# Access Compliance Report

## Public Rights-of-Way

### (Curb Ramps)

Intersection ID: 26897	Main Street: ALEXA_RD	Cross Street: SCOTT_GATE_CT	Location: W
ADA ID: 7EA769ECE725	Ramp Type: BlendTrans1	Initial Pass/Fail: Fail	Overall Compliance: No
		Severity Score: 8.75

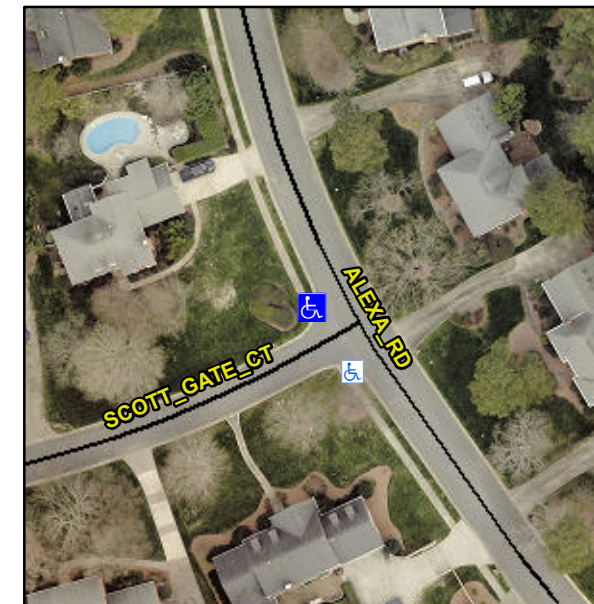
**Not Found, R304.5.1**

**Remove & Replace Curb Ramp With Two New Directional Ramps or Equivalent.**
